*Chick-fil-A Powers and Palmer Park
El Paso County, Colorado*

Grading, Erosion and Stormwater Quality Control Report

CHICK-FIL-A, POWERS & PALMER PARK #05934

Add: PCD File No. PPR2521

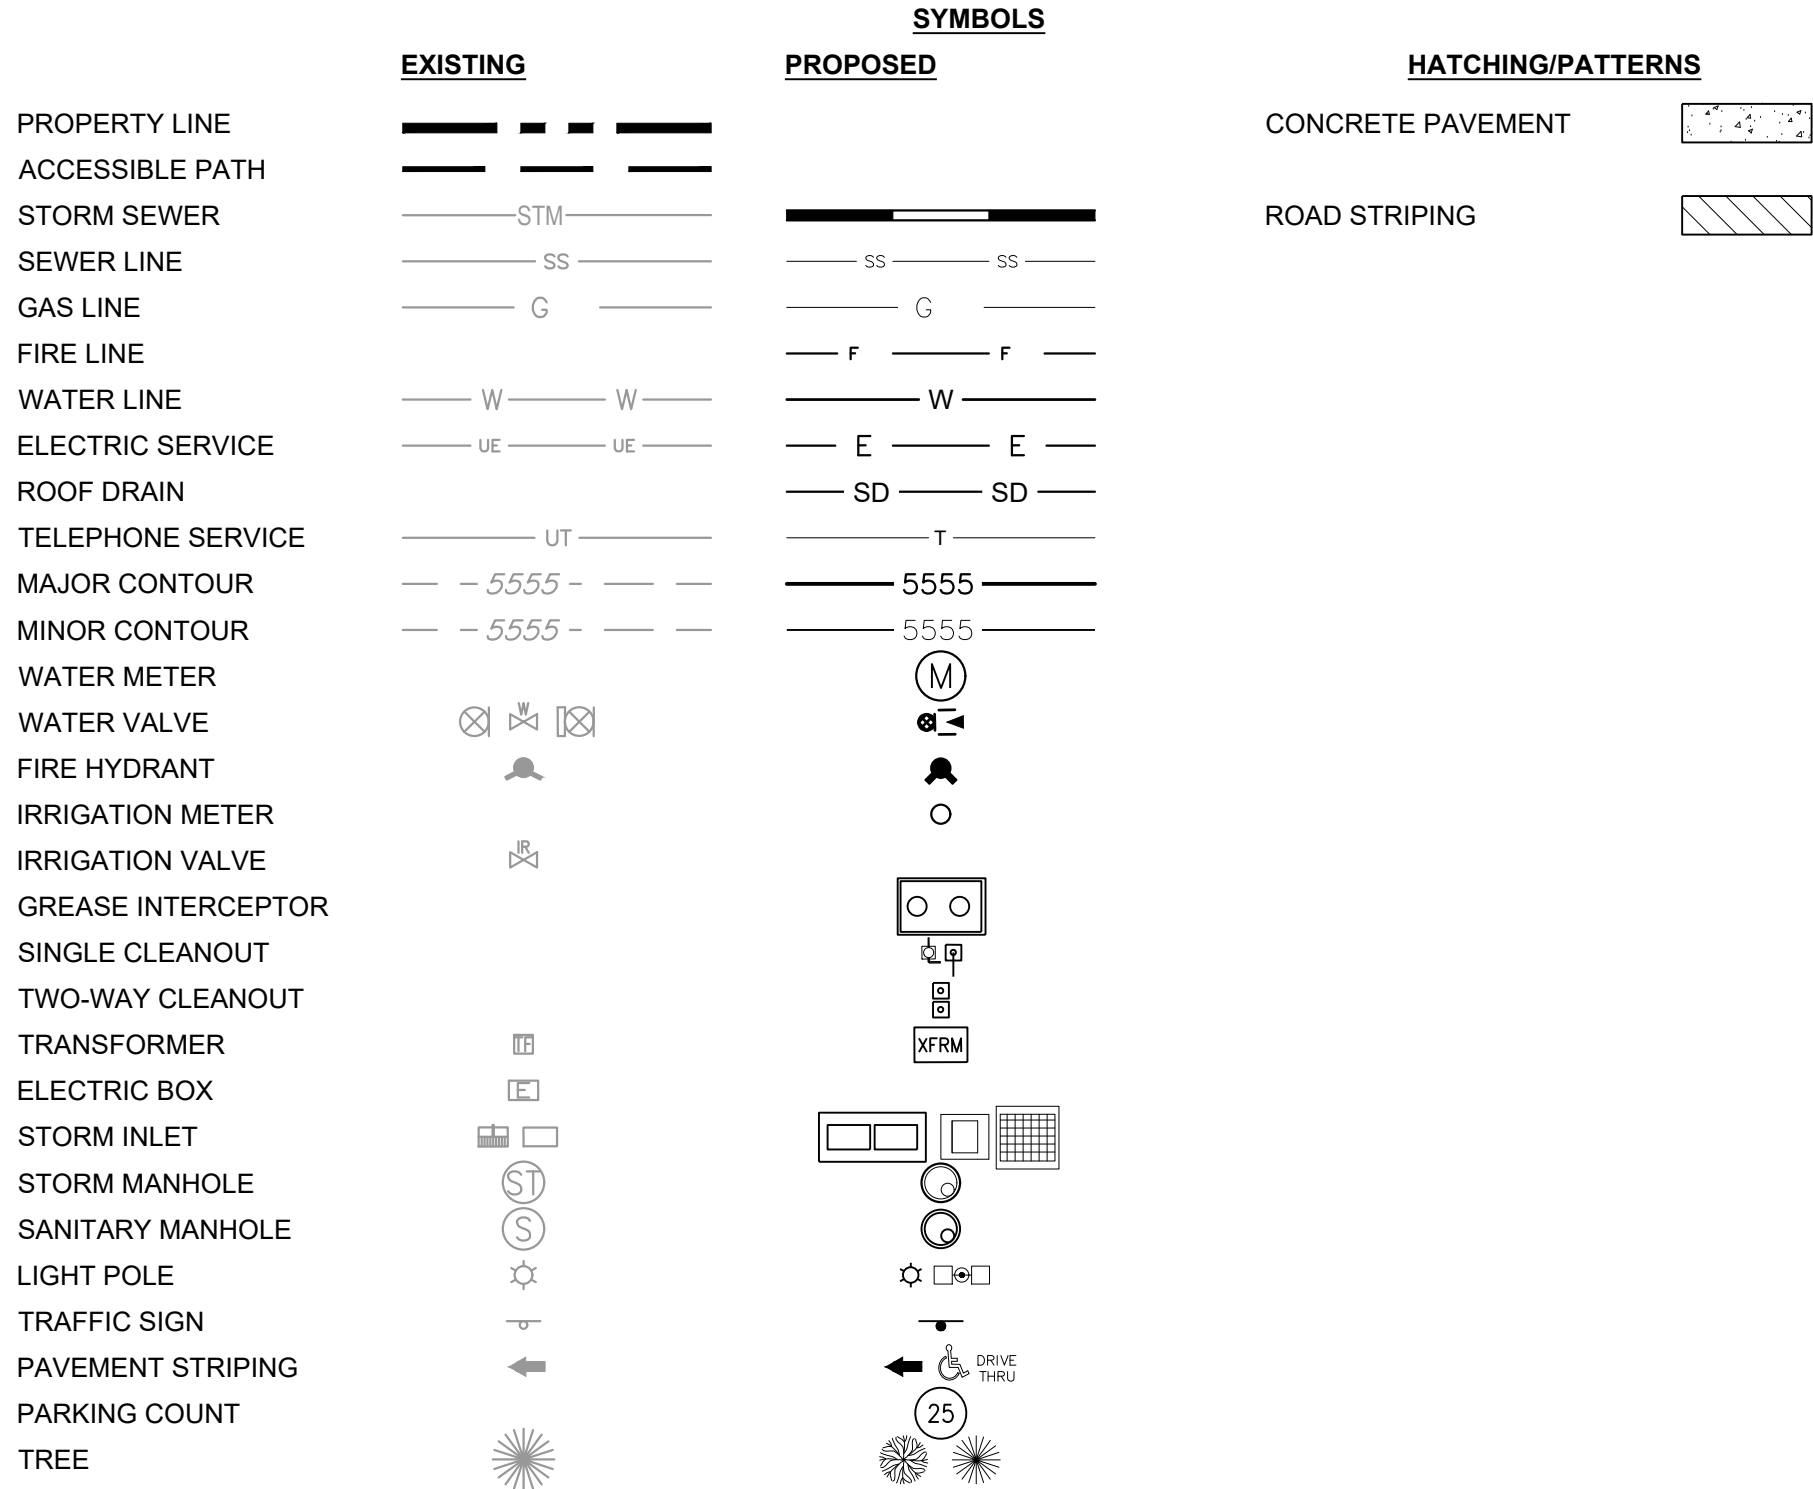
Revise notes to match standard notes for EPC GEC Plans (See attached word doc)

C1.0

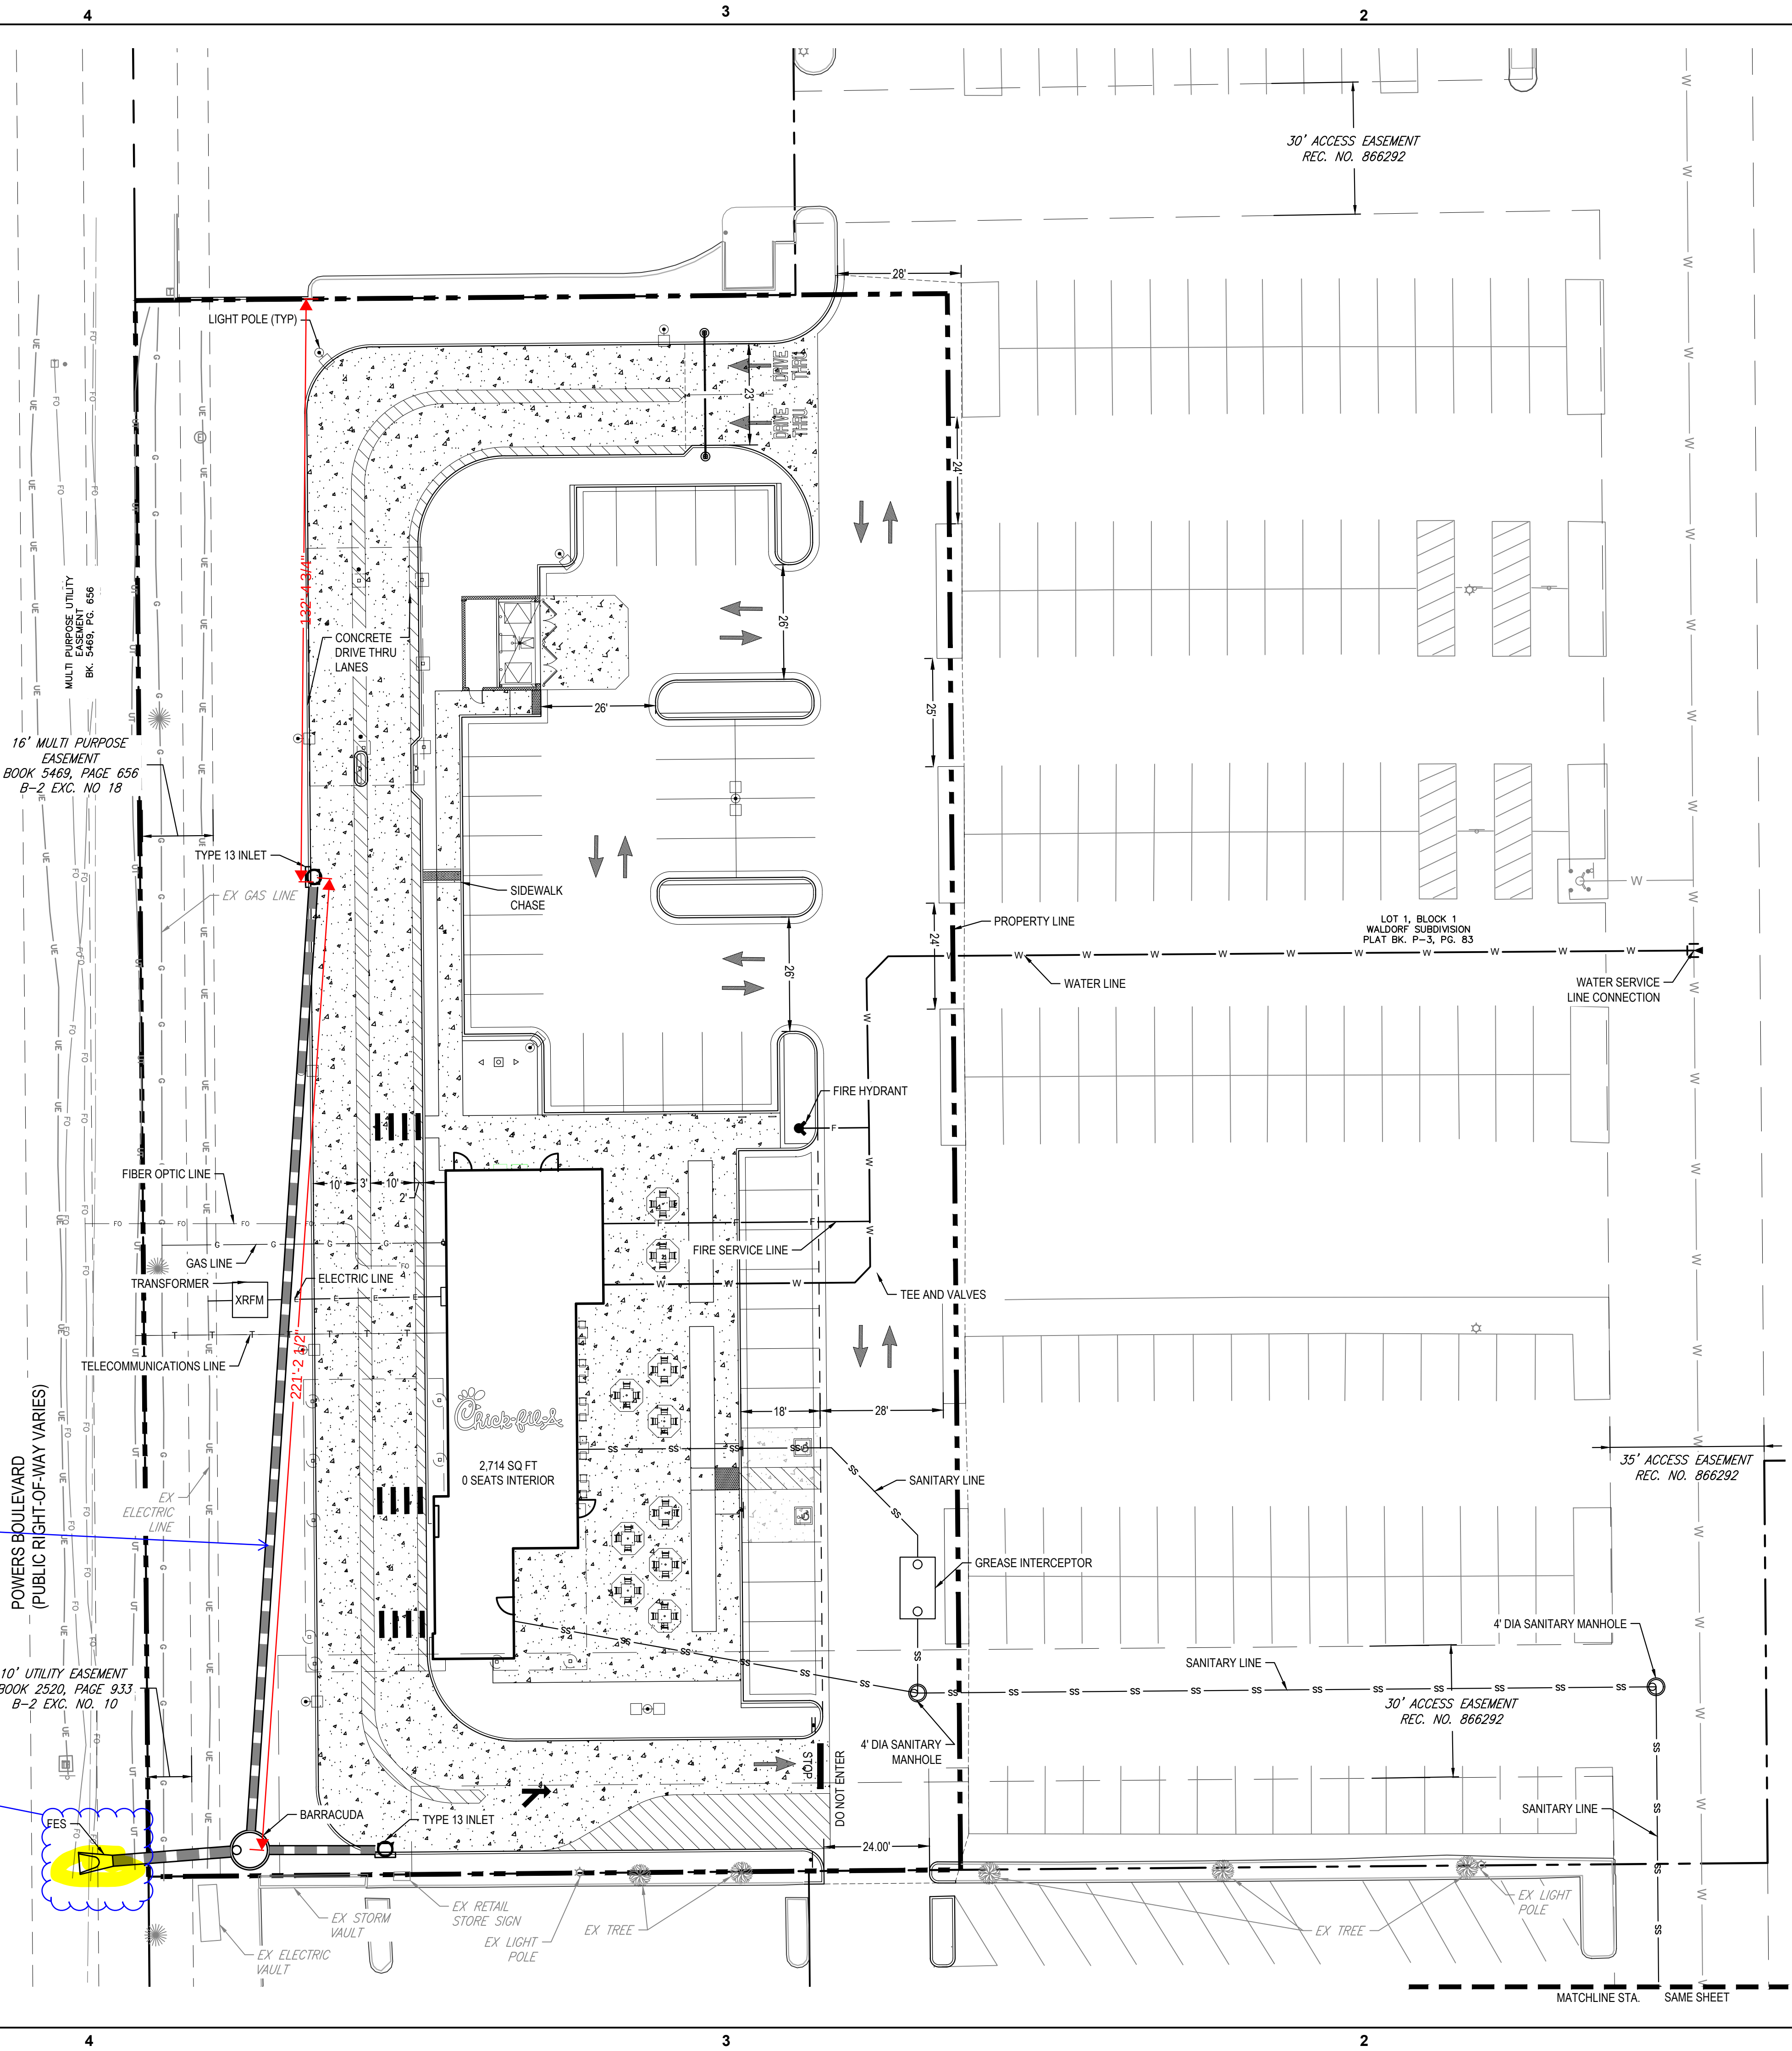
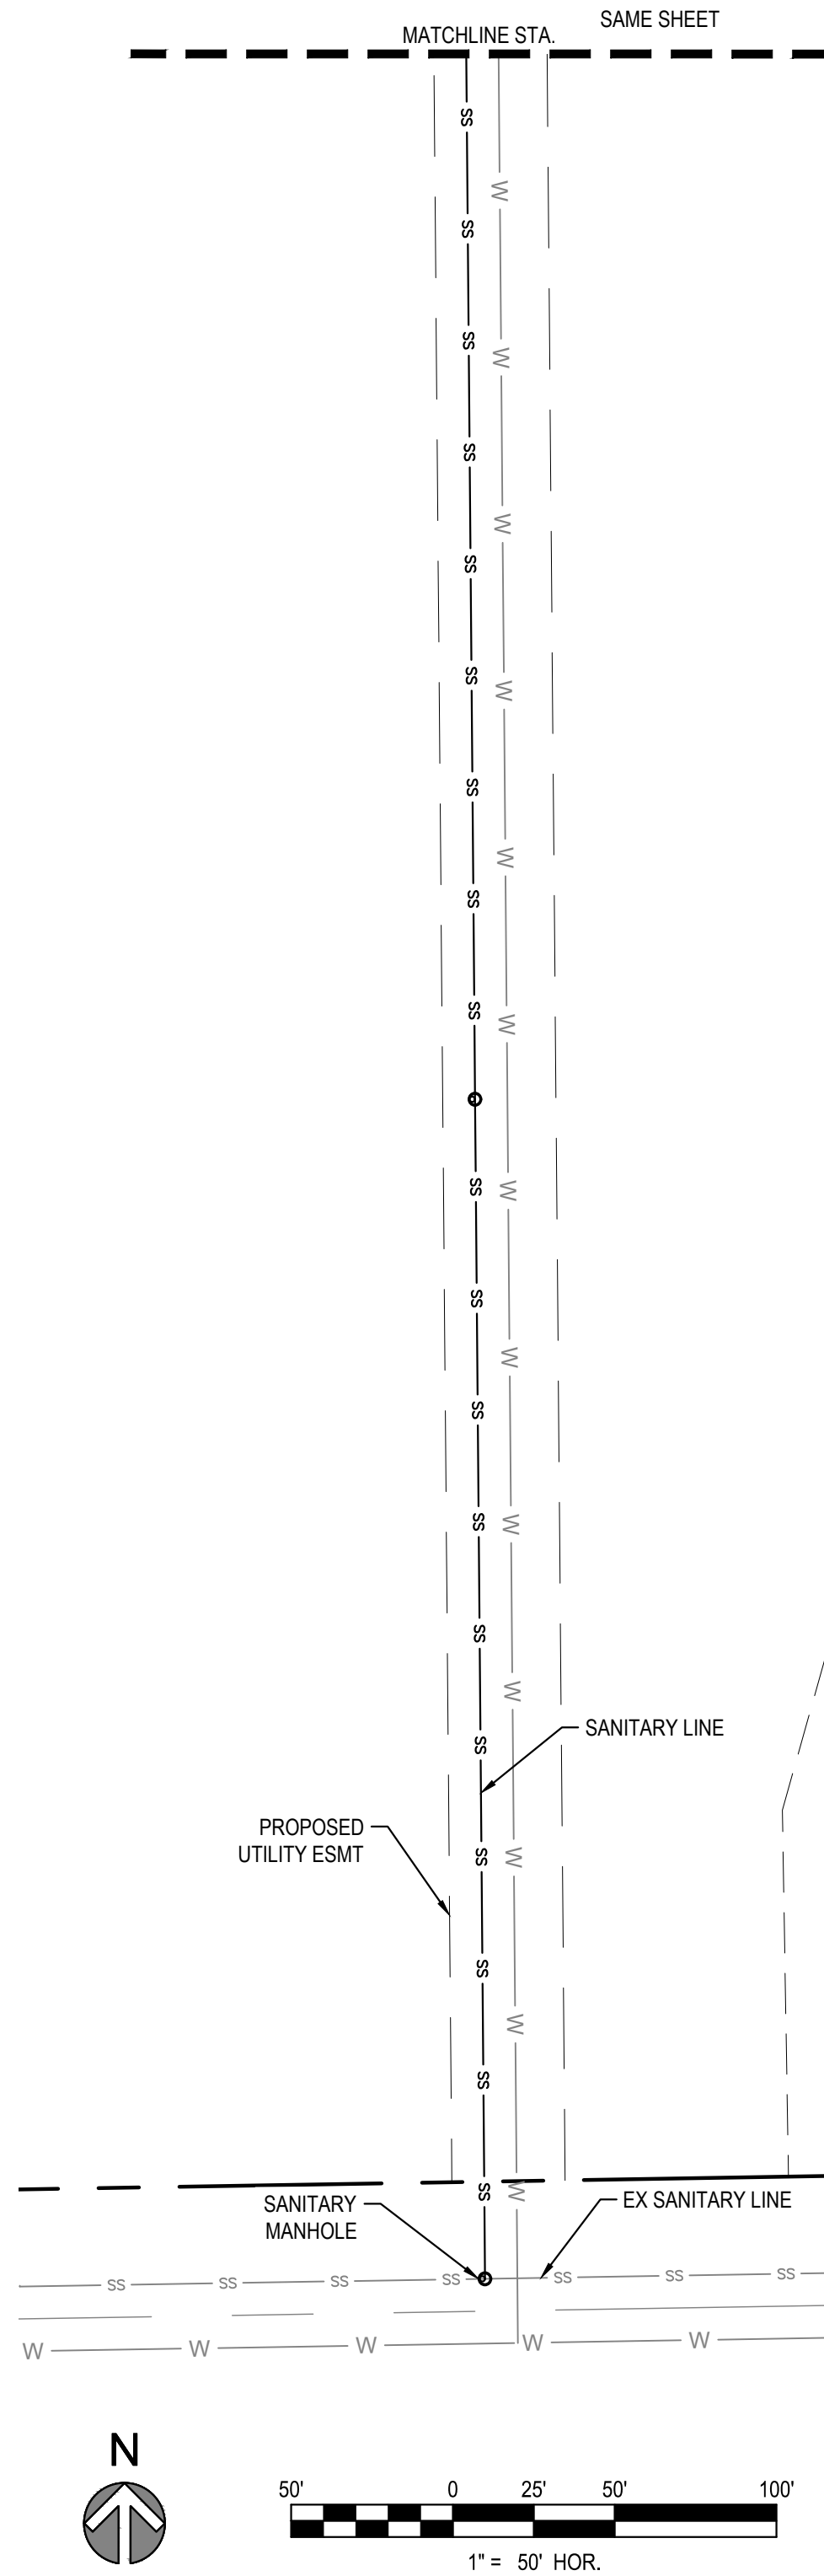
Remove FES out of ROW and provide setback
Show grading with protection needed coordinate with CDOT

label all pipes by type and size

PIPE NETWORK REMOVED IN NEW RAIN GARDEN DESIGN

PIPE NETWORK REMOVED IN NEW RAIN GARDEN DESIGN
